RE: PEN ref: 190684 - Risboro, Nant Mawr Road, Buckley

Meeting held on 22nd February 2018 at 10am

CIIr Bithell invited the complainants present to open the meeting and opportunity was given for both complainants to raise their objections and concerns regarding the development on land at Risboro, Nant Mawr Road, approved under reference 052513 — CONSTRUCTION OF 6 2-STOREY DWELLINGS (the Development).

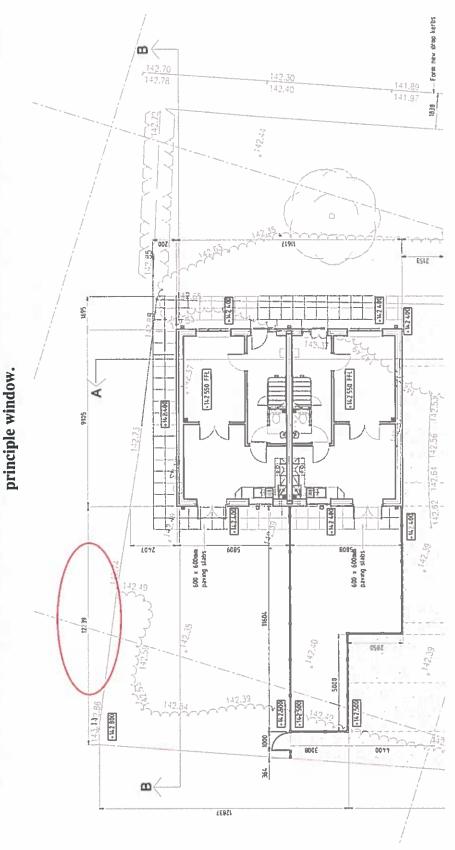
Figure of 13m has been achieved by measuring the midpoint of plots 5-6 to a fence in Dawn Close and NOT principle window to

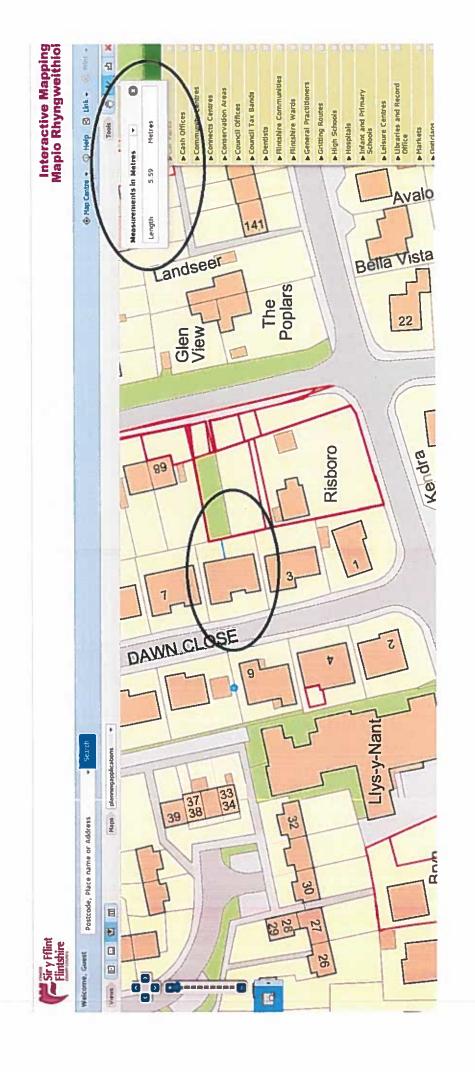
Figure of 5.5m at No5 Dawn Close has been achieved by measuring OS or spatial mapping

Problem Area with distance measurements explained

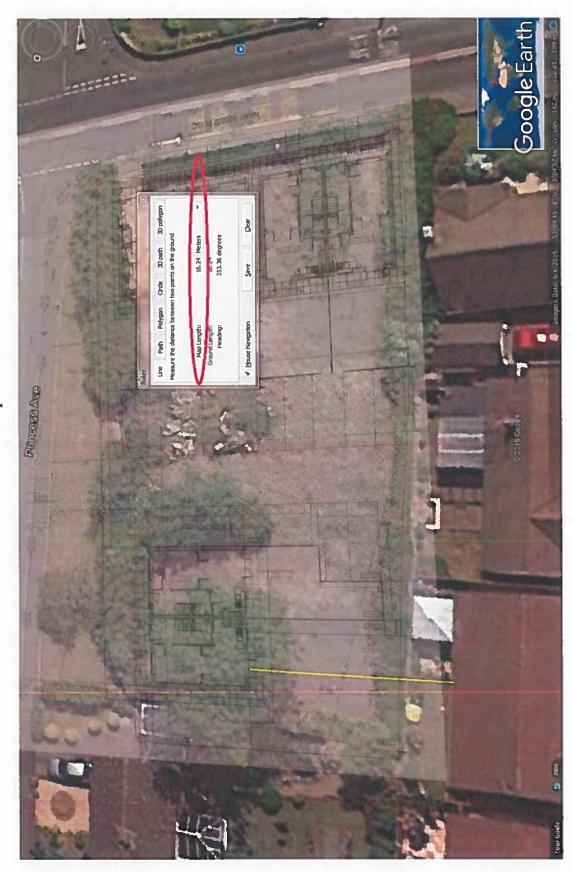
True Distance for Separation 16.2m
